Title - Sujet Palace Grand Theatre Foundation Rep	
Solicitation No. - N° de l'invitation EZ899-152418/A	Amendment No. - N° modif. 008
Client Reference No. - N° de référence du client	Date 2015-07-17
GETS Reference No. - N° de référence de SEAG PW-\$PWY-022-7522	
File No. - N° de dossier PWY-5-38030 (022)	CCC No./N° CCC - FMS No./N° VME
Solicitation Closes - L'invitation prend fin at - à 02:00 PM on - le 2015-07-24	Time Zone Fuseau horaire Pacific Daylight Saving Time PDT
F.O.B. - F.A.B. Plant-Usine: <input type="checkbox"/> Destination: <input checked="" type="checkbox"/> Other-Autre: <input type="checkbox"/>	
Address Enquiries to: - Adresser toutes questions à: Arthur (PWY), Carolyn	Buyer Id - Id de l'acheteur pwy022
Telephone No. - N° de téléphone (604) 775-6667 ()	FAX No. - N° de FAX (604) 775-6633
Destination - of Goods, Services, and Construction: Destination - des biens, services et construction: Parks Canada - Palace Grand Theatre - Dawson City, YT

Amendment 008

BID DOCUMENTS FOR
PALACE GRAND THEATRE FOUNDATION REPLACEMENT

ADDENDUM No. 4
July 17, 2015

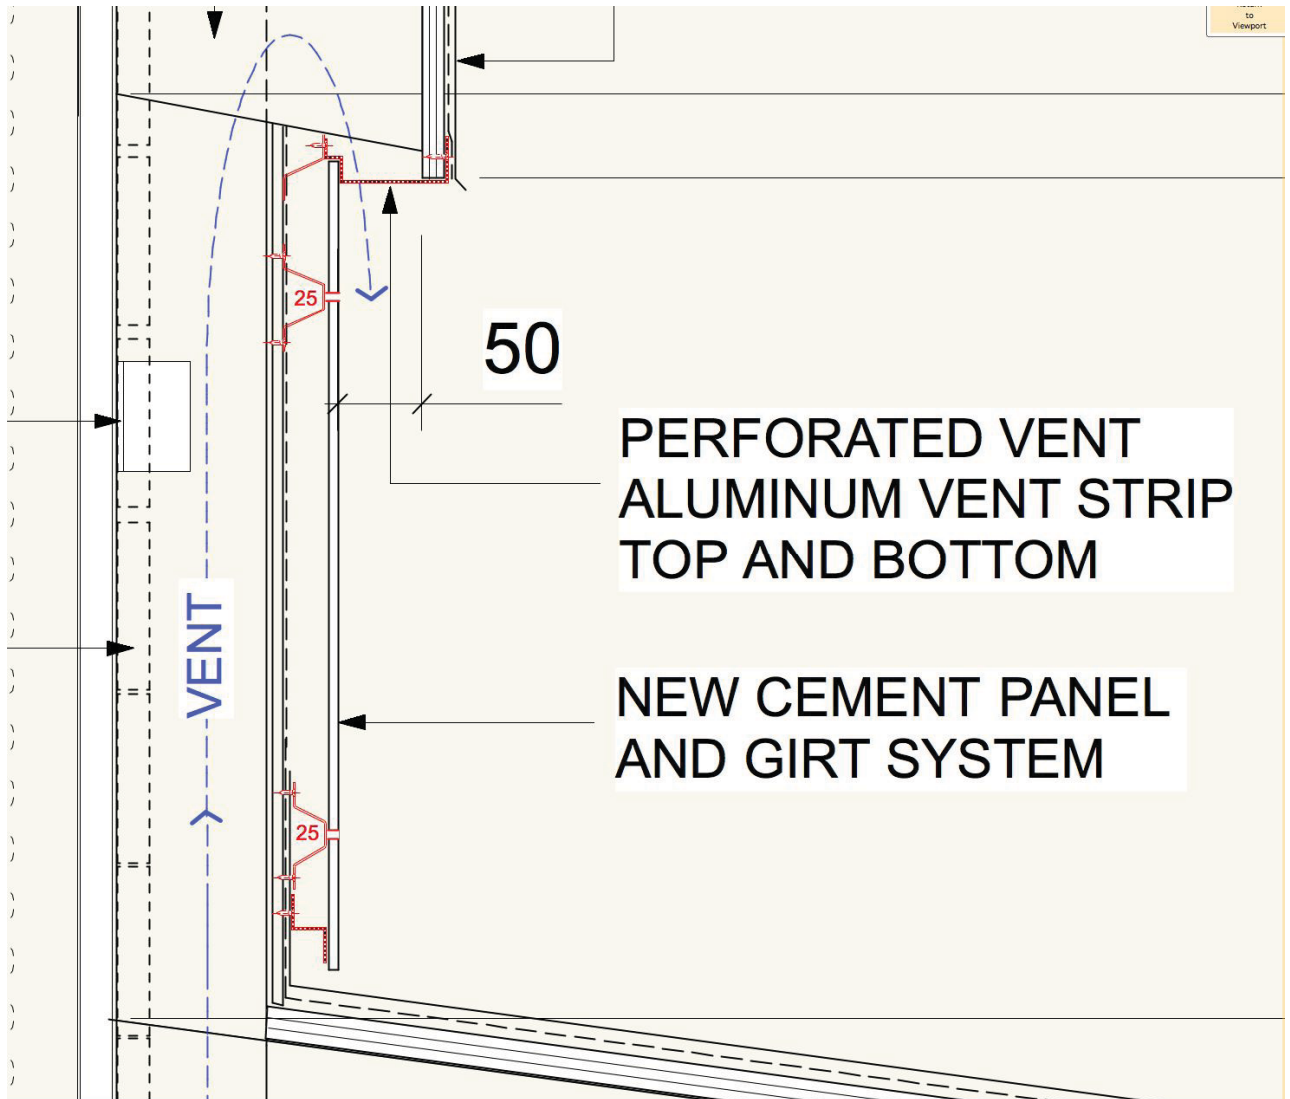
Please provide a specification for the perforated aluminum vent strip as well as a connection detail for the vent strip including connection detail to the new cement panel wall.

Ventilation screens to match material used with proprietary cement panel cladding system, screen should be 0.7mm thick aluminum, 30% open area, no margins, a perforated pattern with minimum hole dia 2mm, @ 5.5mm staggered centres.
Refer to detail below depicting Top and Bottom locations of vent screens attachments and clarification of sub girt depth as 25mm.

1) Drawing A4, 2/A1 NORTH ELEVATION

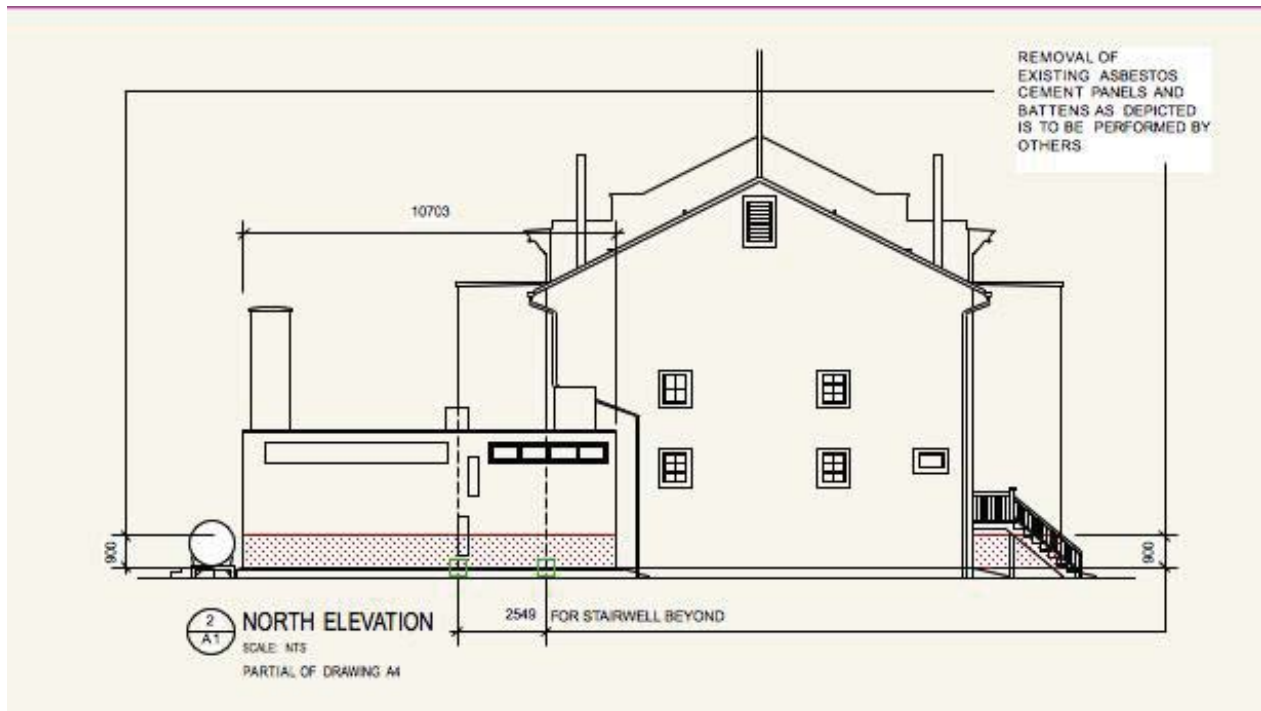
- .1 Delete the removal of asbestos cement panel for extent shown on attached partial sketch.
This work is to be performed by others

2) Drawing A4, 1/A1 EAST ELEVATION

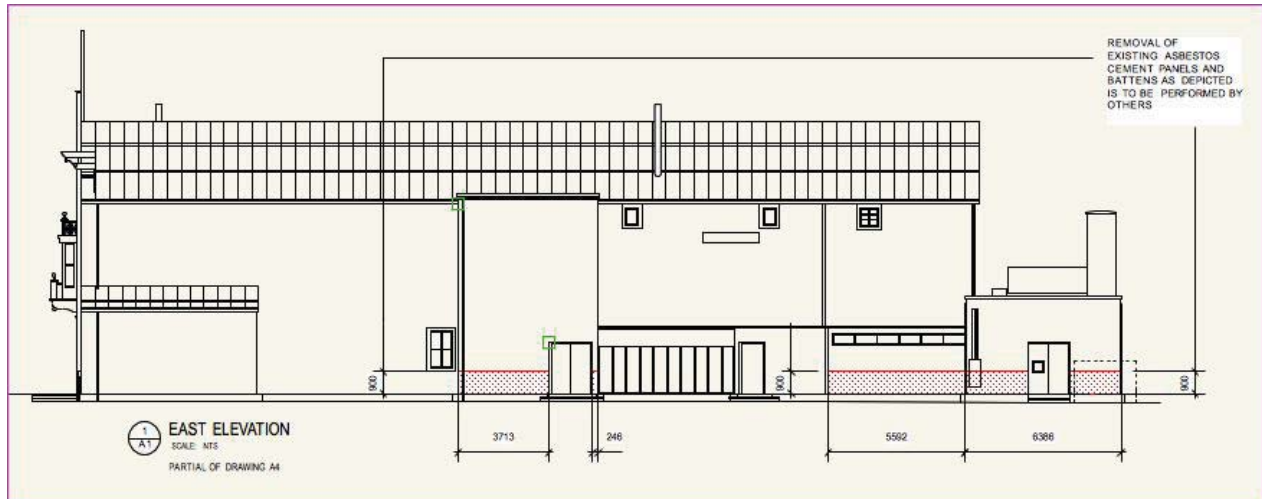
- .1 Delete the removal of asbestos cement panel for extent shown on attached partial sketch.
This work is to be performed by others

3) Drawing A5, 1/A1 WEST ELEVATION

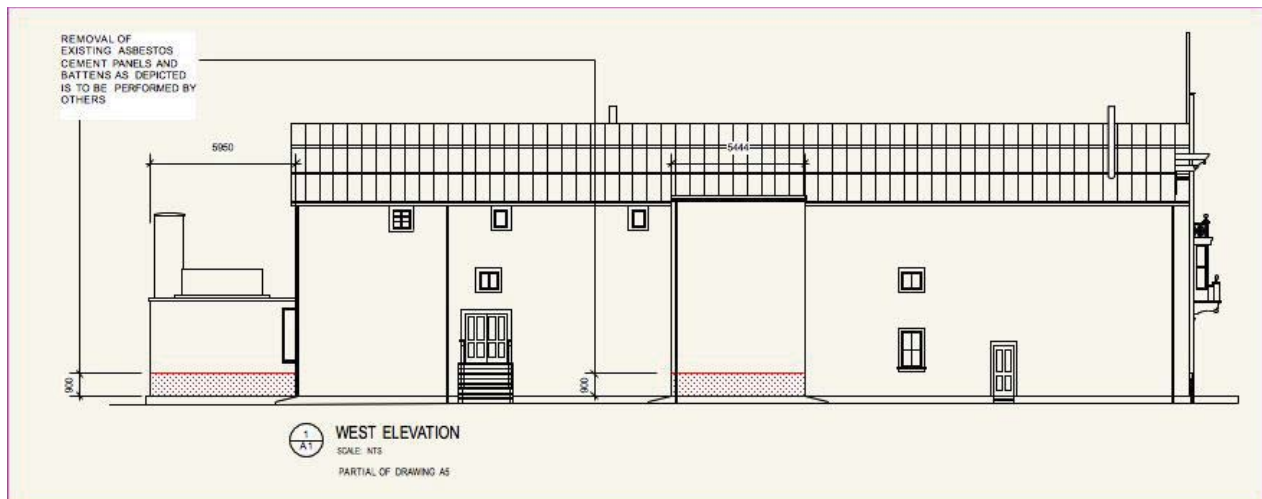
- .1 Delete the removal of asbestos cement panel for extent shown on attached partial sketch. This work is to be performed by others

4) Refer to New sketch SOUTH ELEVATION

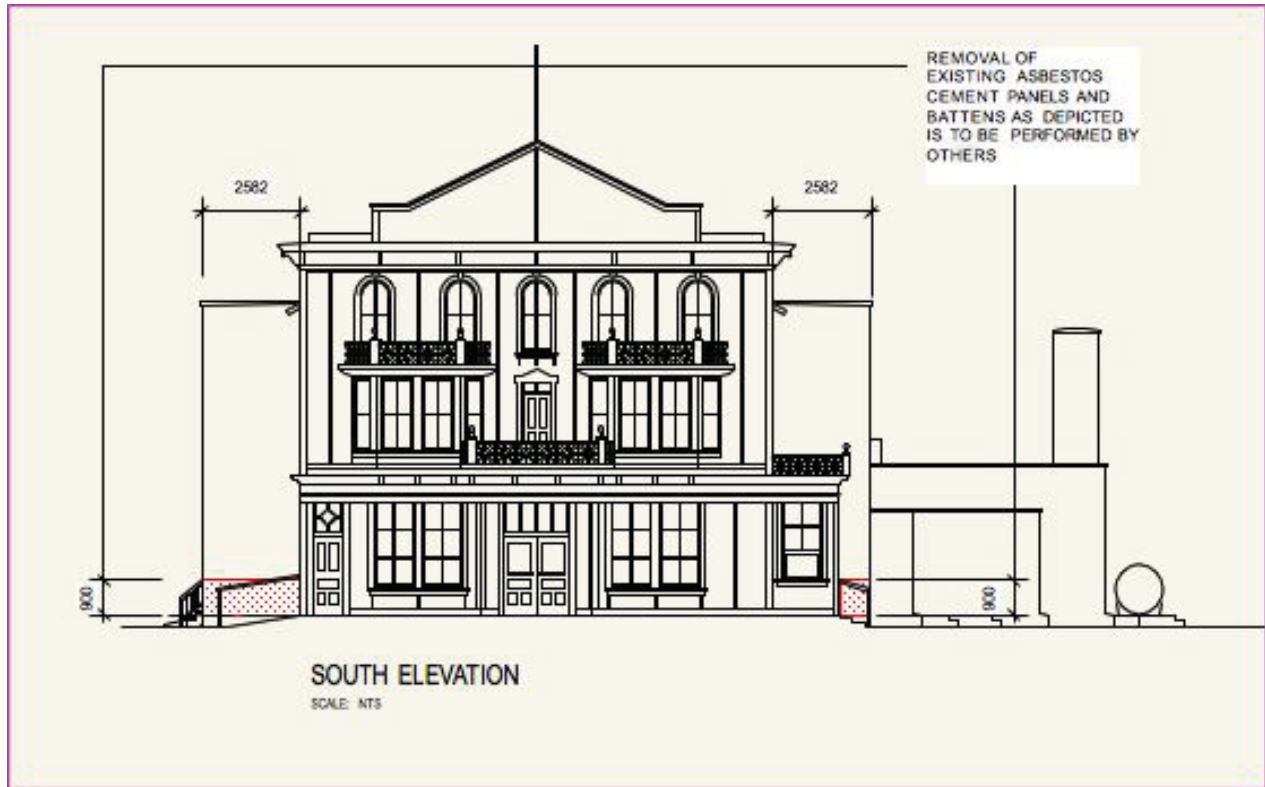
- .1 Delete the removal of asbestos cement panel for extent shown on attached sketch.
This work is to be performed by others
